DRAWING TITLE
LEVEL ONE EAST - HEATING & AIR CONDITIONING

PROJECT TITLE
TERRITORIAL ADMINISTRATION BUILDING
WHITEHORSE, Y.T.

REVISIONS TO LAYOUT DUE TO PARTITION CHANGES

LEVEL 1 - EAST HEATING

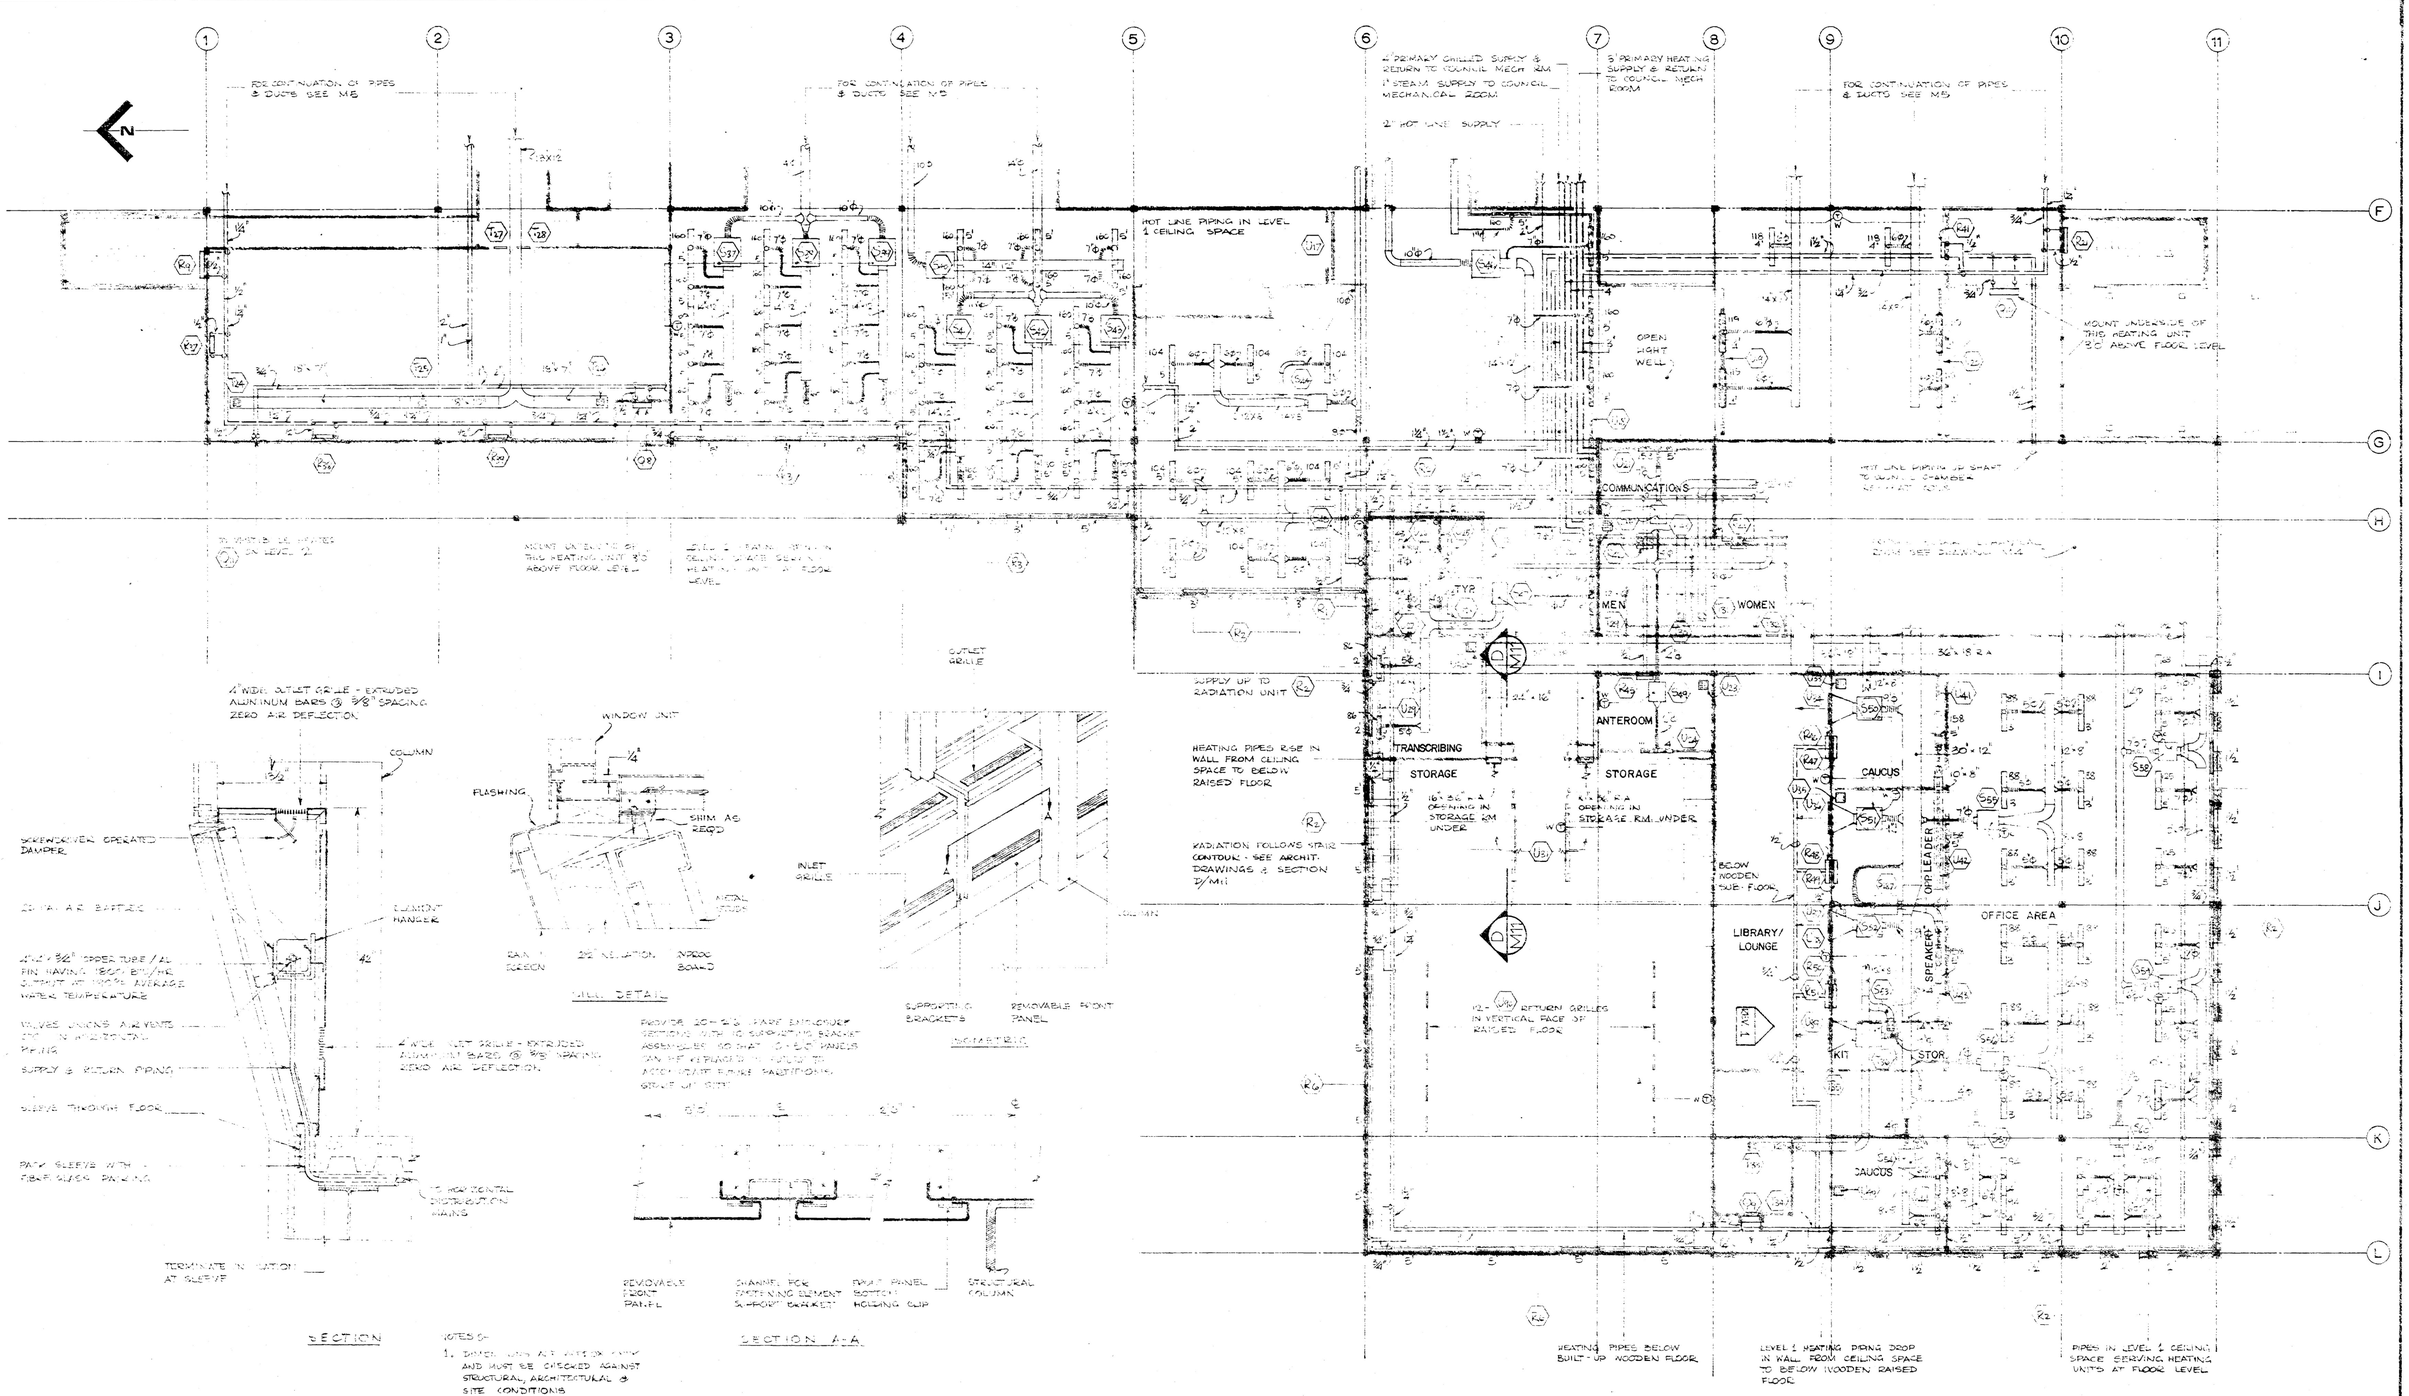
DELETE T16 DOOR GRILLES

DELETE R20 AND SUBSTITUTE R2 FULL LENGTH OF WALL

REVISE SPRINKLER HEAD LOCATIONS TO SUIT NEW PARTITION LAYOUT

1"ϕ SUPPLY DROP (3/4"ϕ TO EACH RUN OF RADIATION)

THE AIR OUTLETS NOT SHOWN ARE TO REMAIN AS THE ORIGINAL M-5 DRAWING.

RELOCATED R32 (SEE DRAWING M10)

RELOCATED R17

½" SUPPLY & RETURN TO RADIATORS IN WALL THICKNESS

NEW RADIATION IDENTICAL TO R17

DRAWING NO.
M6
A

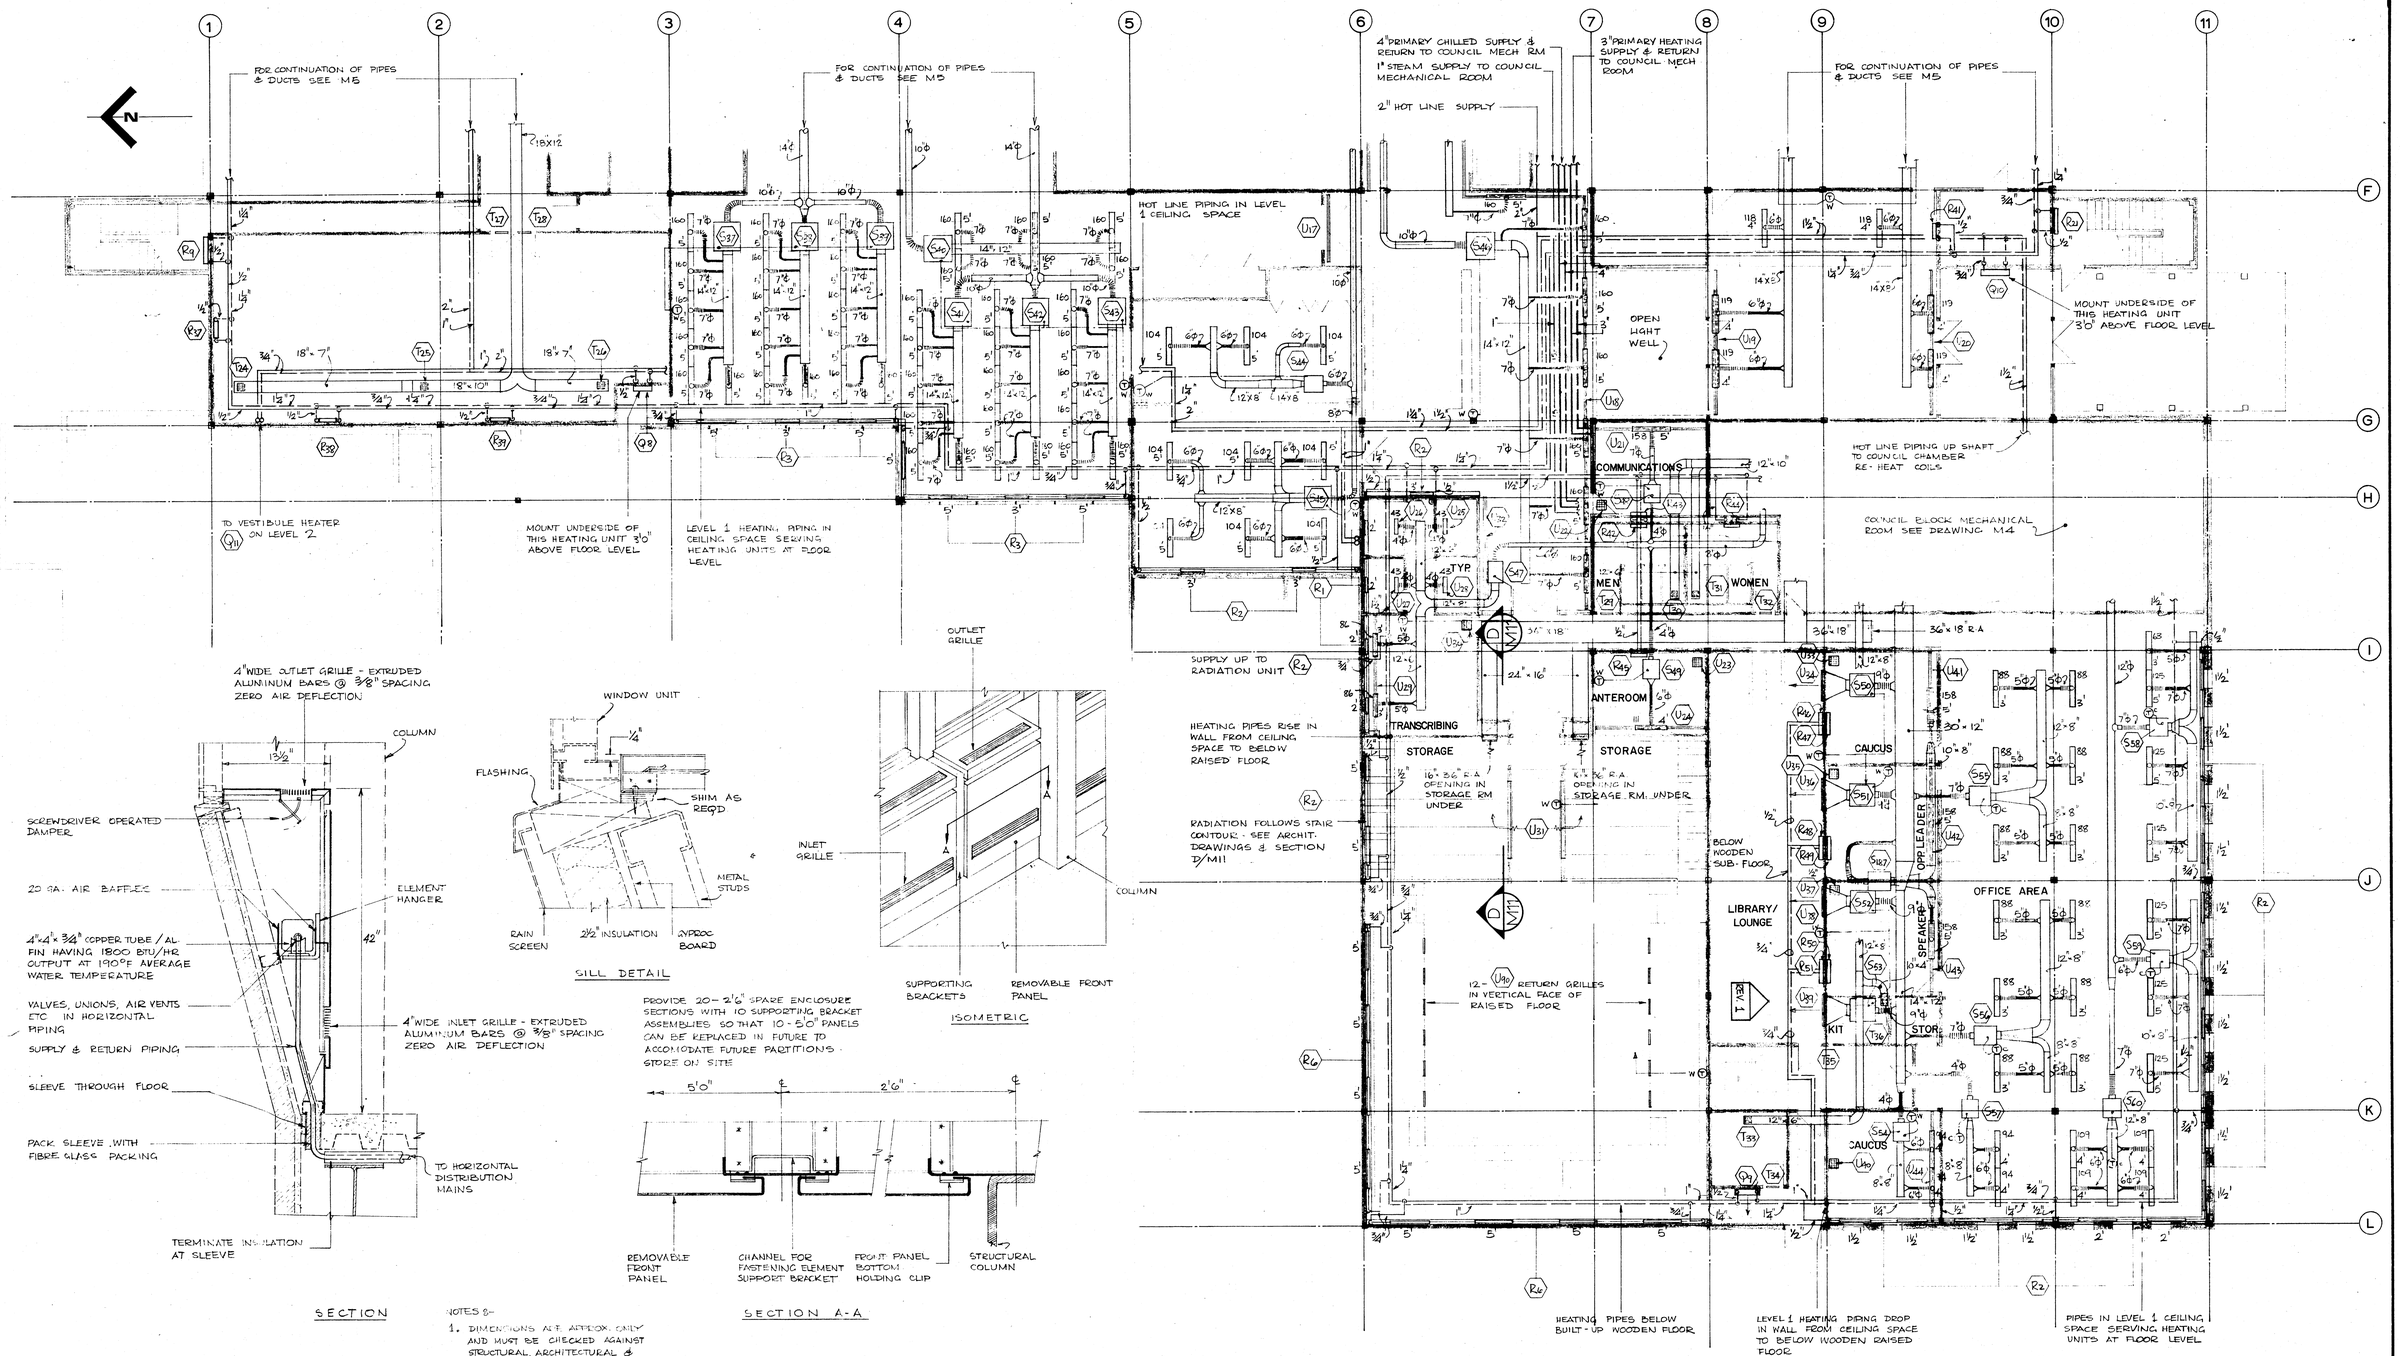
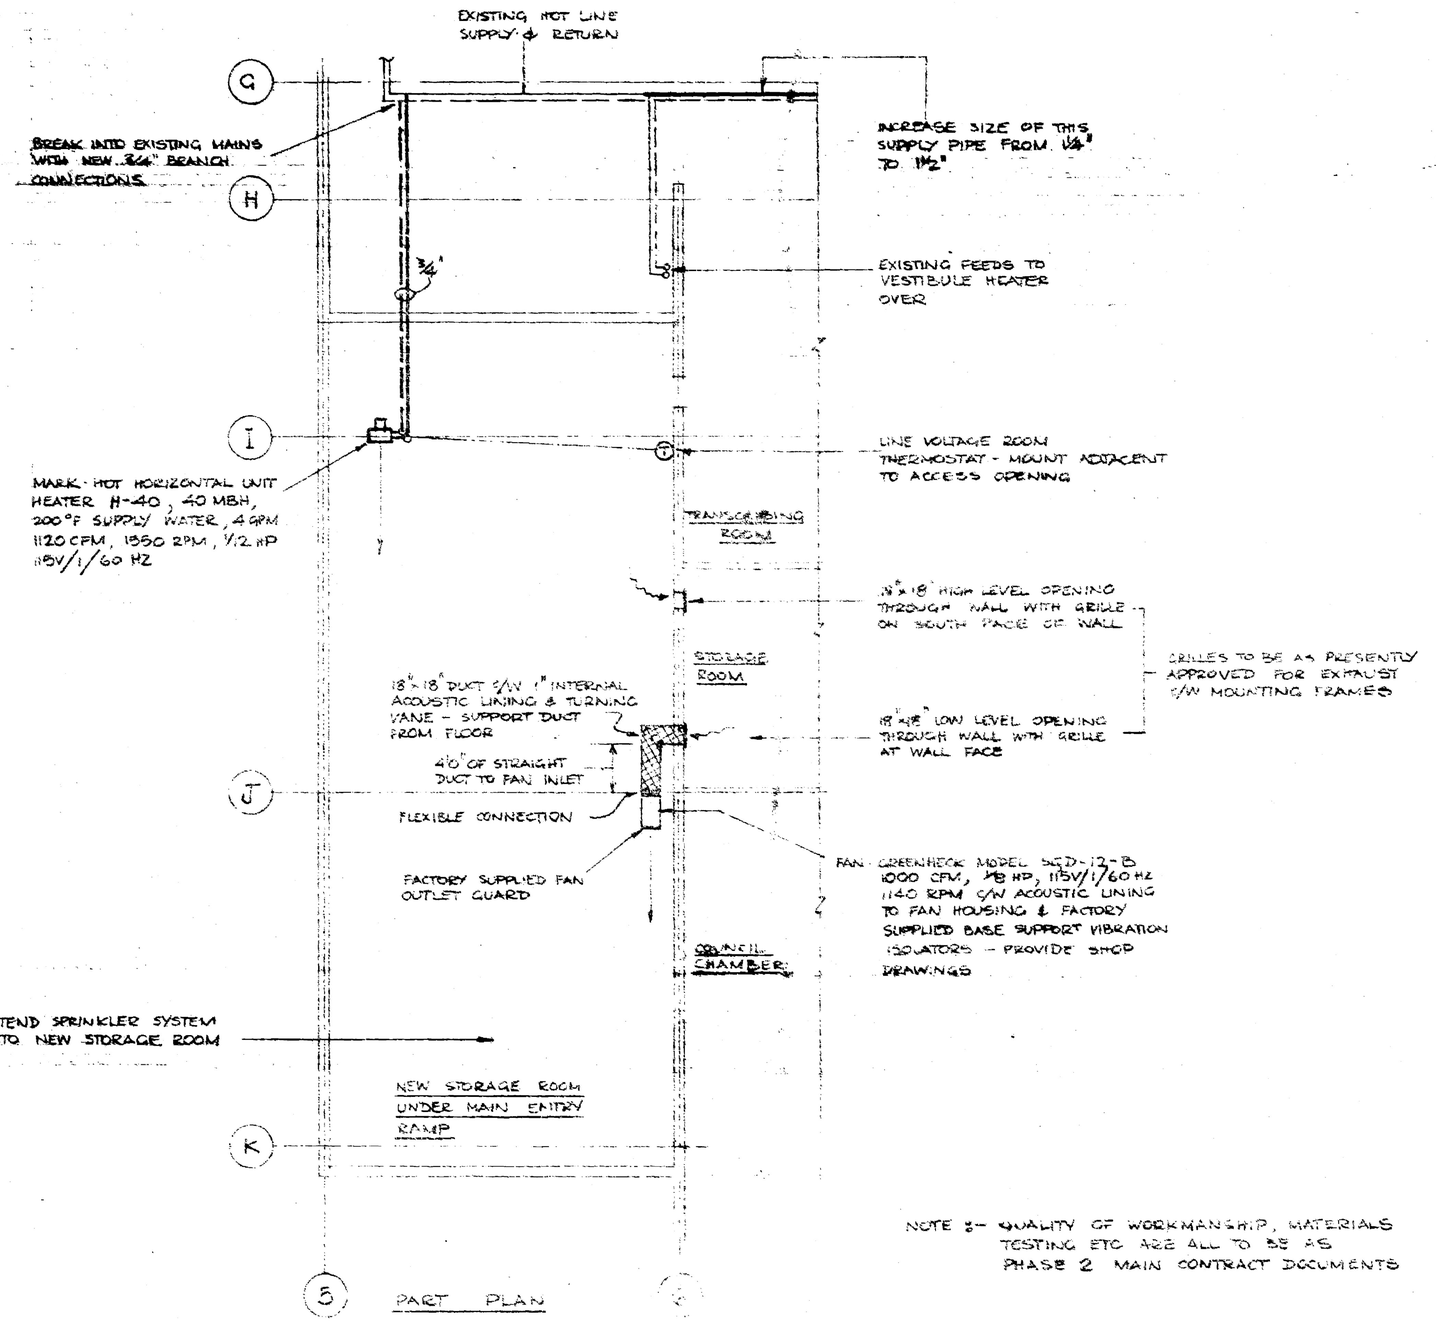
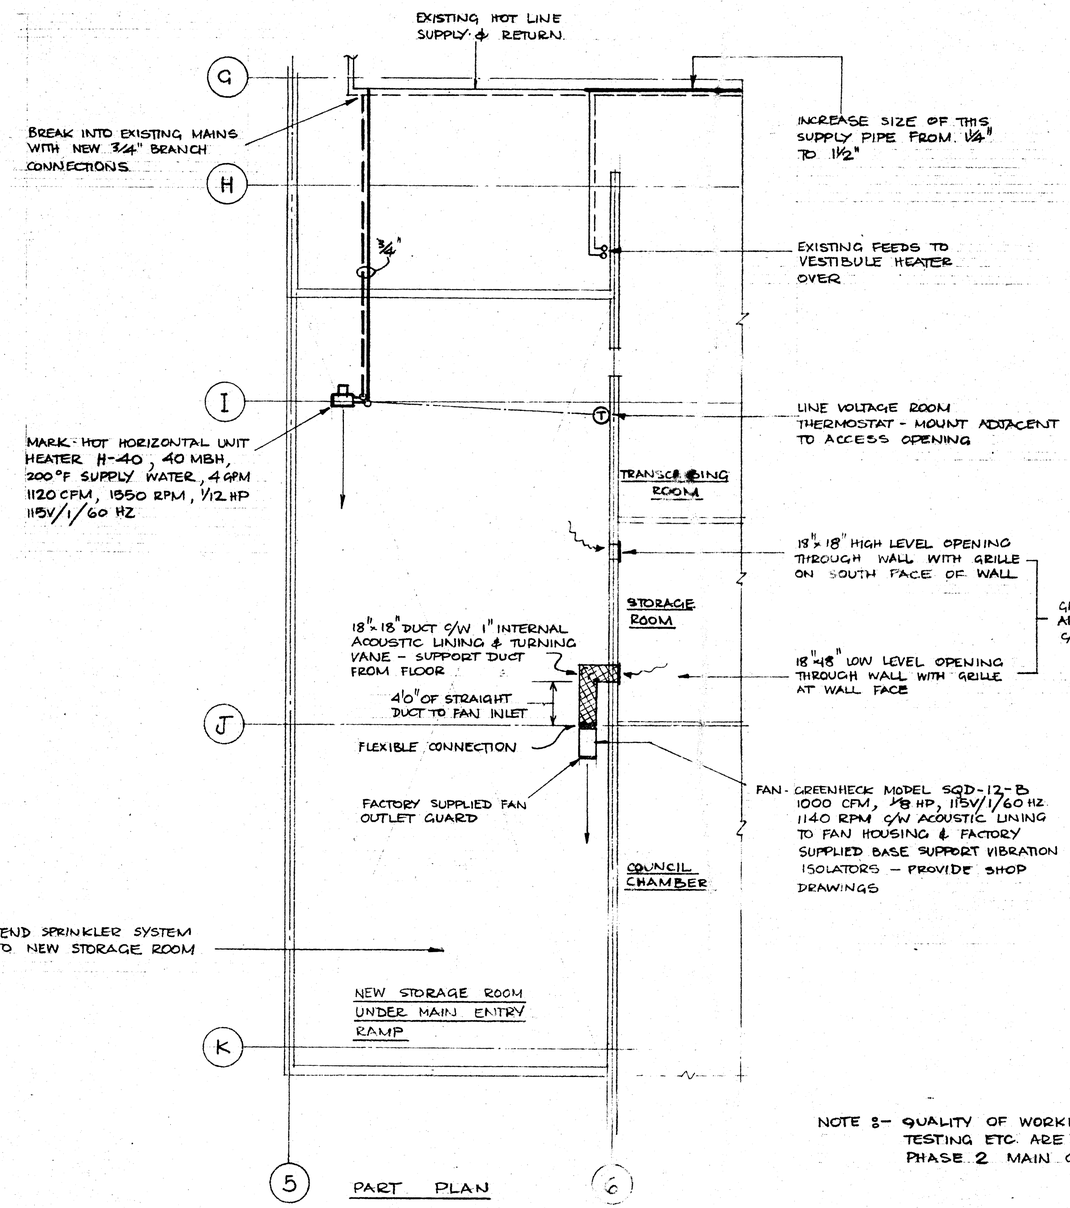
PROVIDE 20 - 2'6" SPARE ENCLOSURE SECTIONS WITH 10 SUPPORTING BRACKET ASSEMBLIES SO THAT 10 - 5'0" PANELS CAN BE REPLACED IN FUTURE TO ACCOMODATE FUTURE PARTITIONS - STORE ON SITE

REVISIONS		
NO.	DATE	DESCRIPTION
1	30 AUG 74	ADD. 1 HEATING PIPES SERVING R46 TO R51 RELOCATED BELOW LIBRARY/LOUNGE FLOOR

DRAWING NO. M 10 A

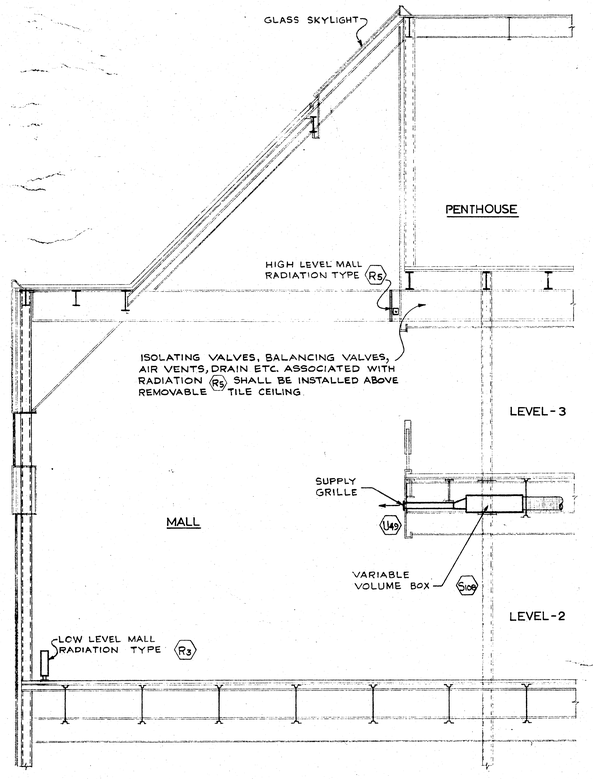
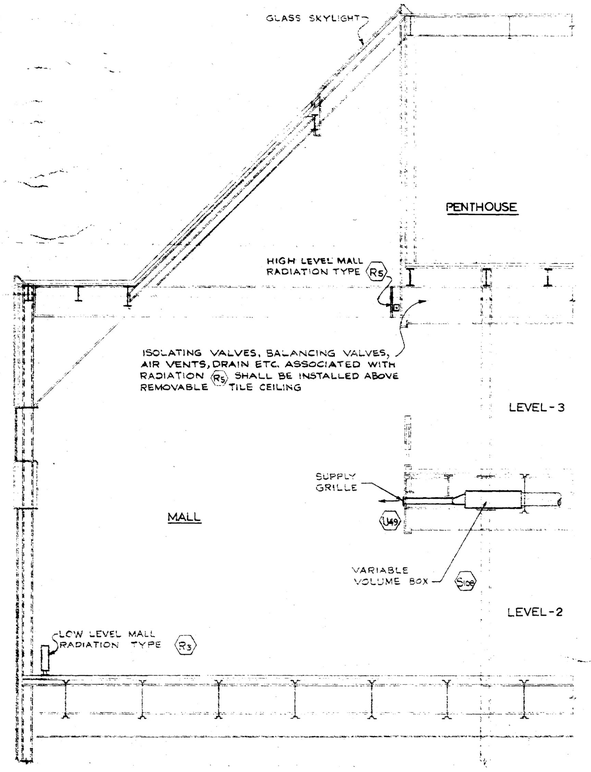
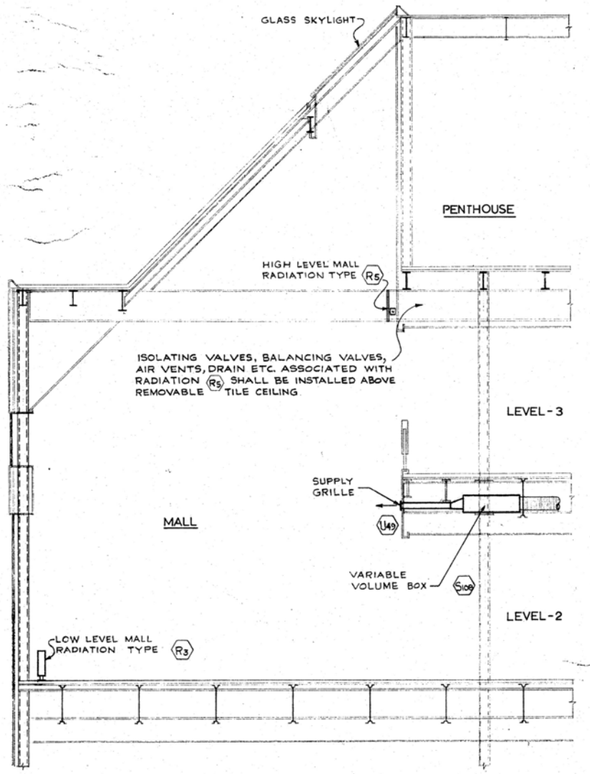
REVISIONS		
NO.	DATE	DESCRIPTION
1	MAY 24	ADD A LEVEL 1 SHAFT FIRE DAMPERS IN SIDEWALLS NOT AT FLOOR PENETRATION

ALL FIRE DAMPERS MUST BE ACCESSIBLE EITHER THROUGH CEILING TILE OUTSIDE OF SHAFT, OR ACCESS DOORS IN GYPROC CEILINGS OR FROM INSIDE OF SHAFT.
